NOTIFICATION 17-12-08

Subject: Canopy Latch/Handle Upgrade

Affected Models: All RV-12 Aircraft

Required Action: Replace old handle and latch block components with revised components.

FIGURE 13: CANOPY UPPER CENTER SEAL TOP VIEW

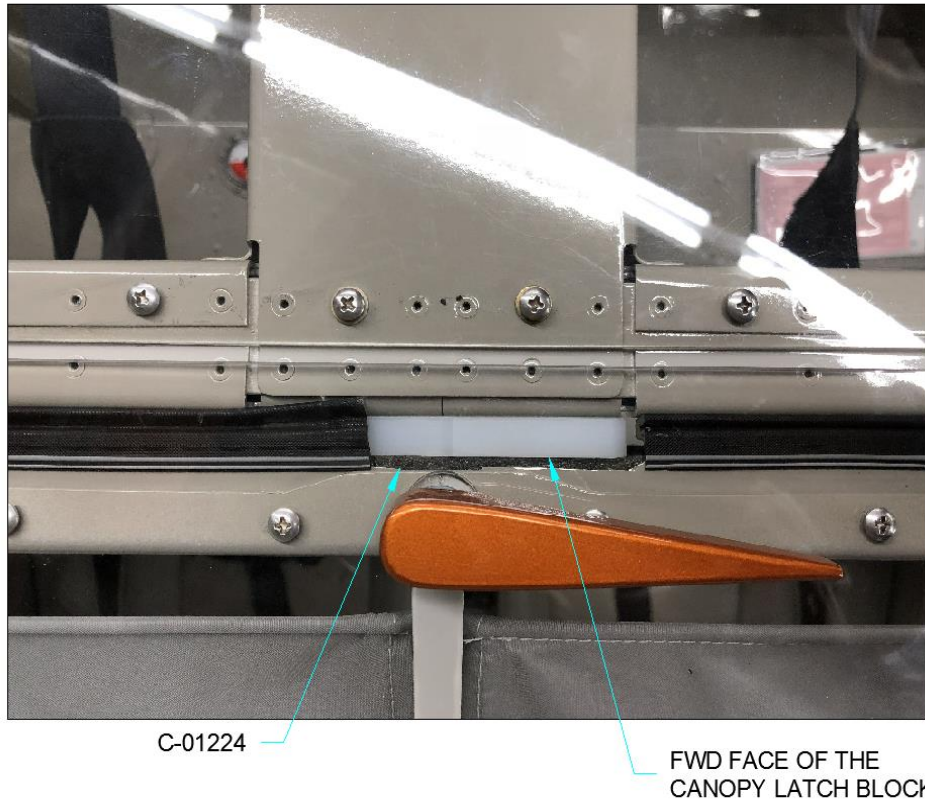
Step 21 (Seal Kit Installed): Close the canopy. Looking straight down, place a piece of tape aligned with the forward edge of the canopy latch block. See Figure 13 and Figure 14.
